Sunbury South Precinct Structure Plan

Landscape and visual review

For: Hi-Quality Quarry Products Pty Ltd

August 2017 | Final

Figure 3 Precinct Features (Source: PSP, Plan 2)

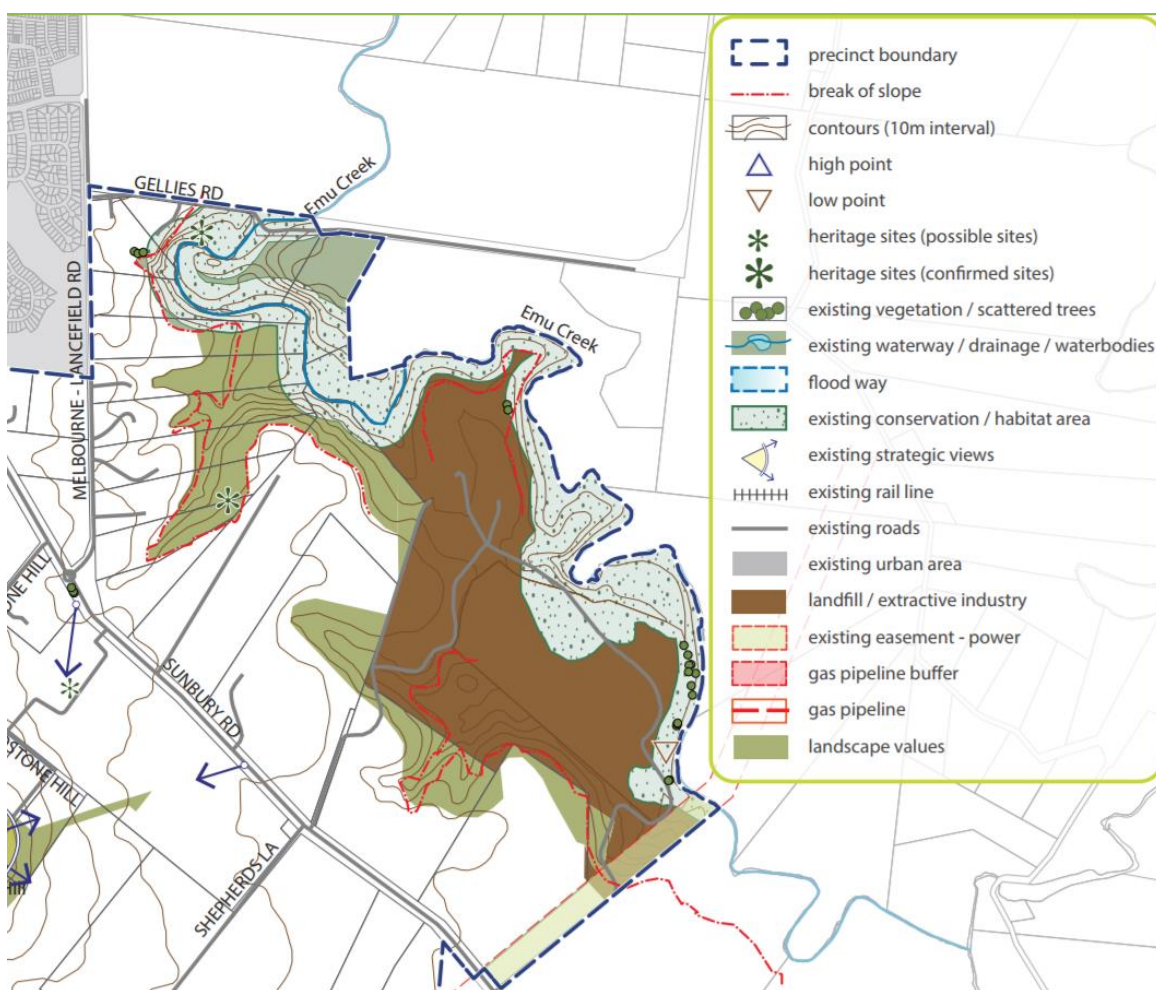
The extent of the “landscape values” area follows that of the original designation of the ESO1 in the upper areas of the Hi-Quality land and includes the area above the ESO10 to the ‘break of slope’.

The area designated as “landscape values” does not follow a particular contour line but broadly includes two incised valleys and the land between the ‘break of slope’ and the area designated as “existing conservation / habitat area” in the north east section of the Hi-Quality land.

Figure 6 Contours

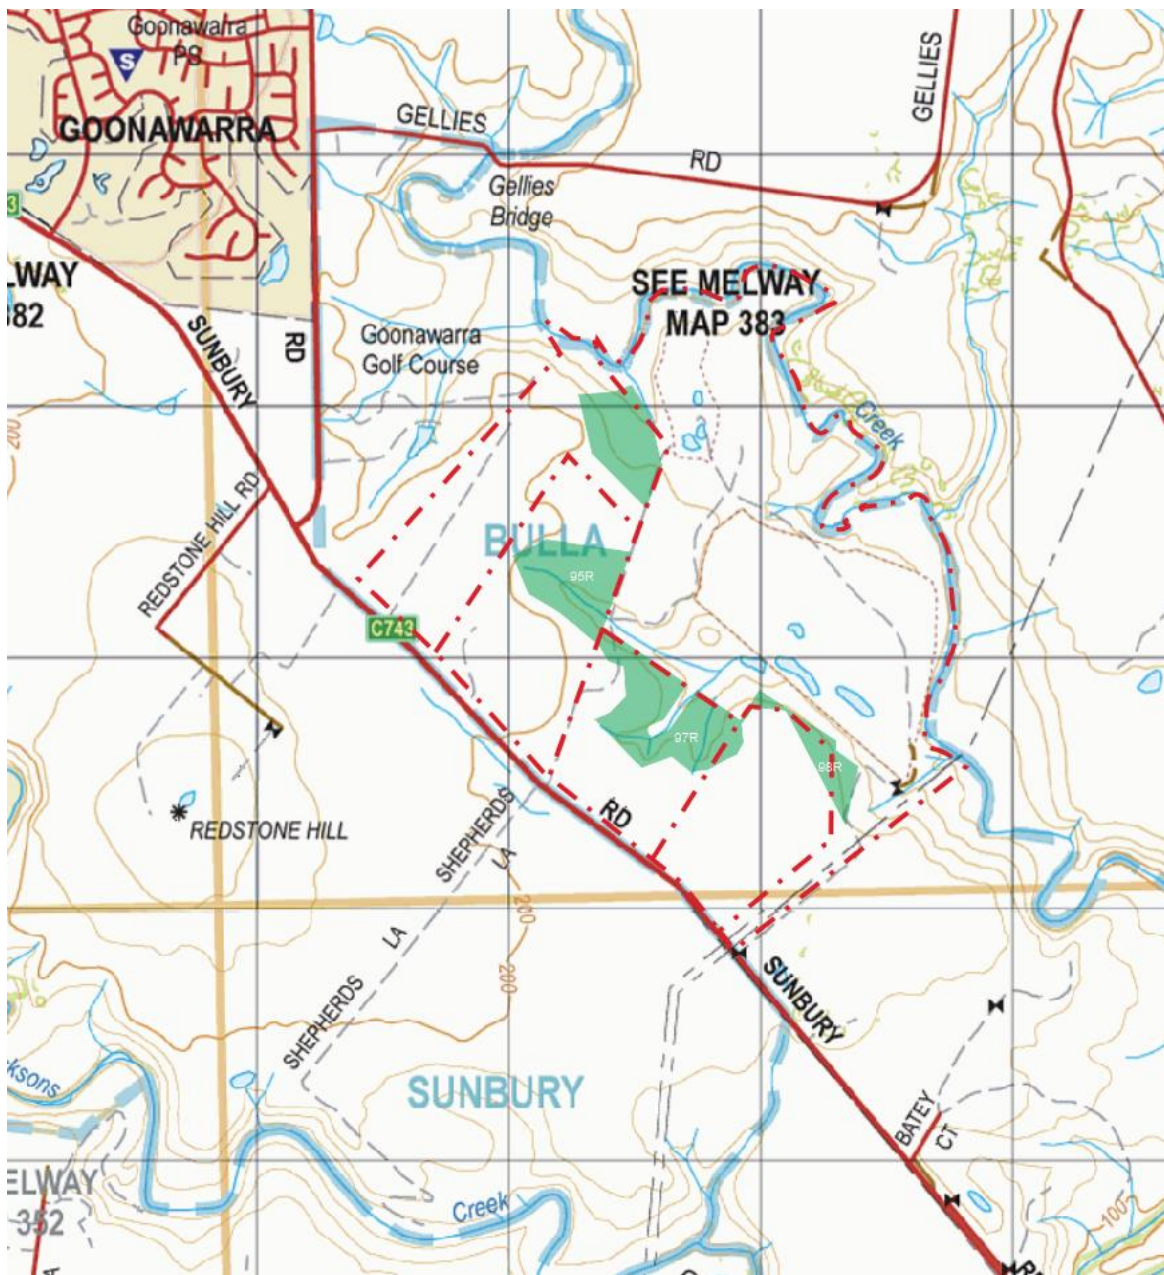
Figure 6 also shows those areas designated as 'landscape values' within the PSP. These areas were originally part of areas designated within the ESO1 and ESO10, which was more extensive and extended across Emu Creek to the land further north (Refer **Figure 2**).

Examining areas designated as 95R and 97R on the PSP. The original SLO areas have been roughly truncated at the title boundary within the PSP. An existing permit allows filling and modification of the existing valleys to the north of the title boundary. This remnant area does not have a landscape basis for its inclusion into areas designated as having 'landscape values'.

Examining the undesignated area to the north west, it is apparent from the contours that this area is not consistent with the contours and the 'break of slope' definition used within the PSP is not parallel to, or aligned with, either the 180m or 200m contour. This area does not have 'landscape value'.

Figure 8 Viewpoints

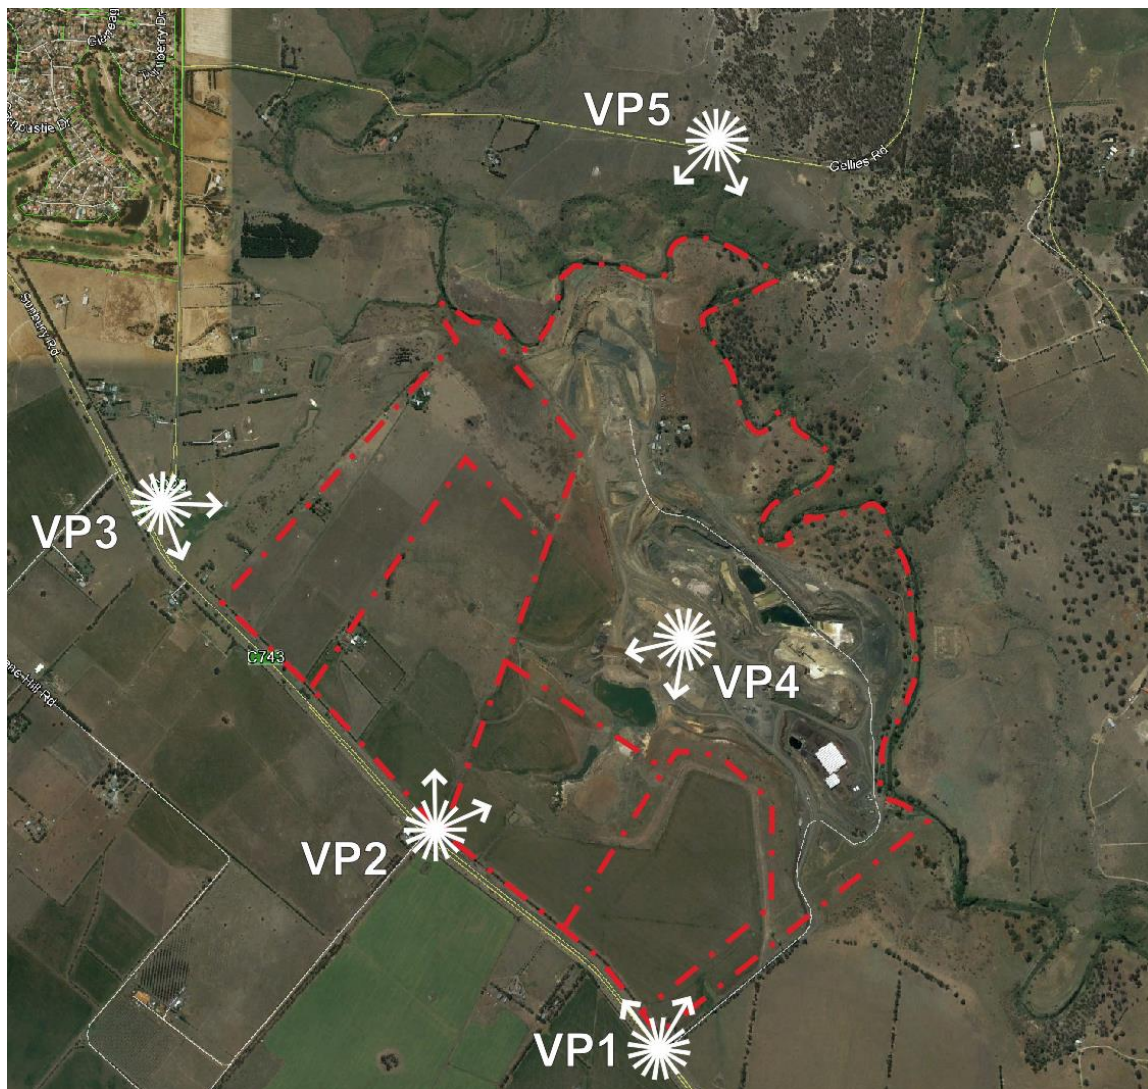
Topography limits views from Sunbury Road to Emu Creek and to the incised valleys that are within the ESO.

I have visited the site and inspected viewing locations along Sunbury Road to ascertain if the visibility of these valleys could be such that they have a 'landscape value' which may have been the reason for their inclusion into the initial ESO and incorporation into the PSP.

Figure 15 Proposed masterplan (Source: Taylors, 10 August 2017)

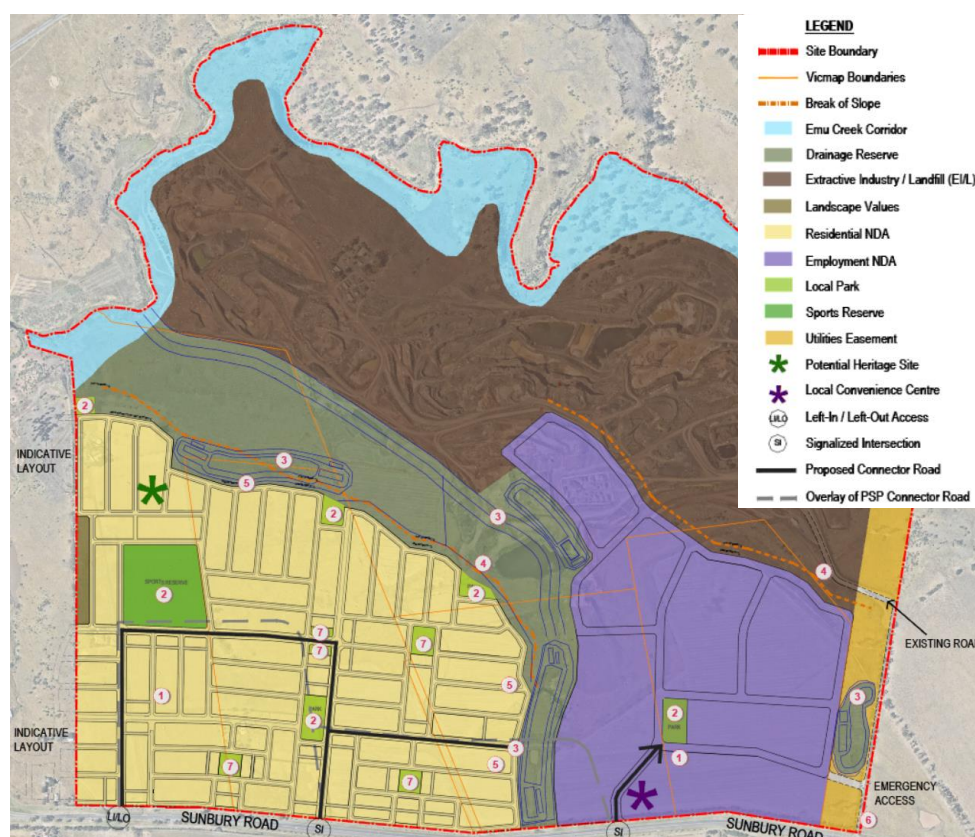
The indicative layout shown in **Figure 15** illustrates a road side verge treatment for much of the proposed subdivision roads along the edge of the break of slope / drainage swale. The break of slope line shown in **Figure 15** is from the PSP. An accurate break of slope line based on the existing contours is shown on the Alluvium plan (refer **Figure 14**).

Proposed changes would improve the interface between the drainage corridor and the proposed subdivision. Currently the plan shows a minor road parallel to the drainage reserve, although in sections allotments are backed to the drainage reserve.

- Provide a boulevard running continuously along the drainage corridor edge. This could show a smoother edge to the open space, but generally in alignment with the current road shown on the subdivision masterplan.
- Provide pedestrian pathway networks which use both the upper edge (adjacent to the proposed wetlands and swale) as well as linking Sunbury Road and Emu Creek along the drainage corridor).
- Relocate the major open space sports area adjacent to the drainage corridor to add to the perceptual size of this major recreation area. The large open space shown on the eastern side of the masterplan (Sports Reserve) could possibly be relocated to the east or the north, perhaps aligning with the proposed fill areas in the east, but more importantly along the proposed boulevard edge.
- Ensuring direct linkages to the outer boulevard from the vehicular entries into the residential land.

Figure 16 Sketch of road layout & pedestrian pathway option

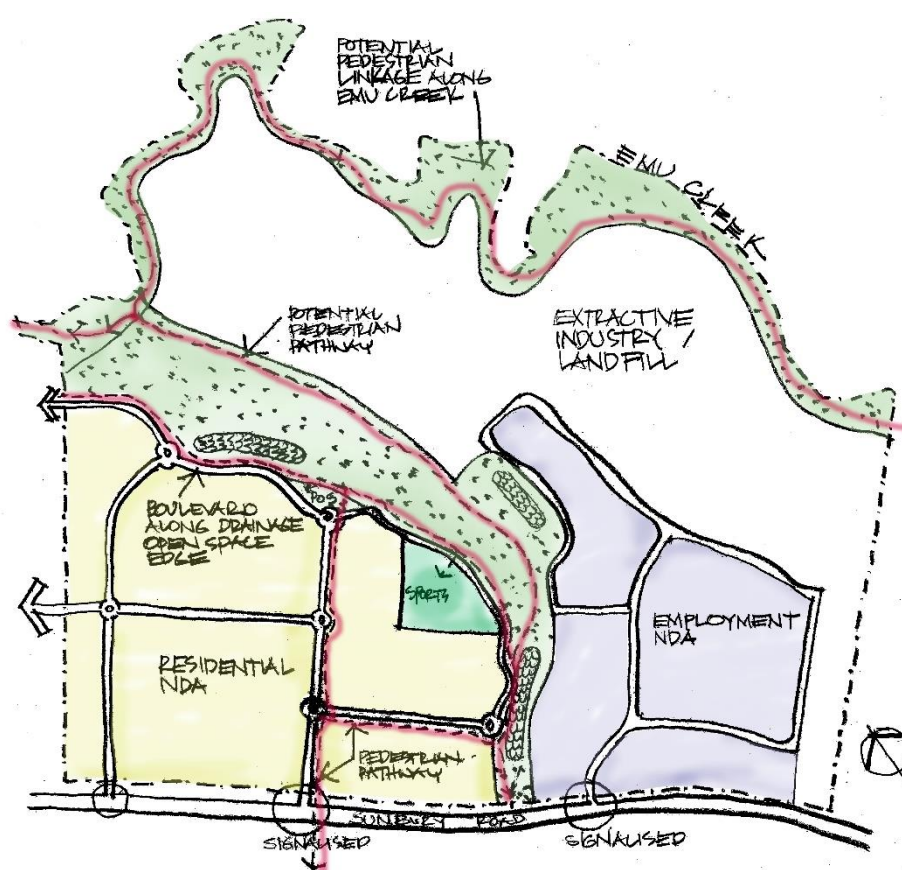
Figure 16 shows that a boulevard running around the perimeter of the residential land that affords an opportunity for views into the drainage reserve and associated wetlands as well as Emu Creek valley which, in the future, will be a major environmental linkage with high landscape values.

Figure 17 Proposed boulevard treatment

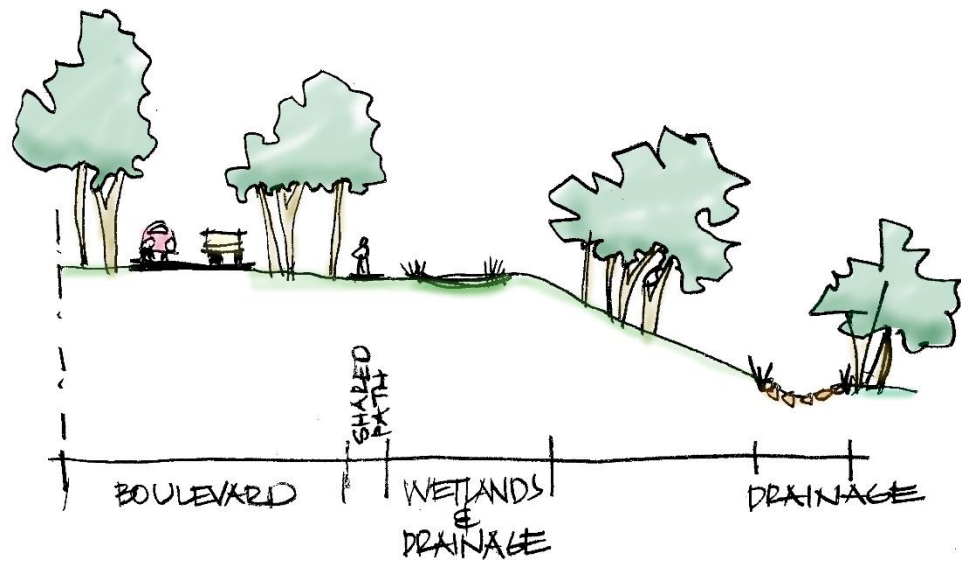
Figure 17 also shows that as a result of the drainage swale and wetland where proposed, the boulevard is set back from the break of slope. I do not believe that this distance should be specified as in the PSP. The specified distance of 20.2m (PSP) seems arbitrary and the boulevard should meander adjacent to the drainage reserve, sometimes closer and sometimes further from the 'break of slope'.
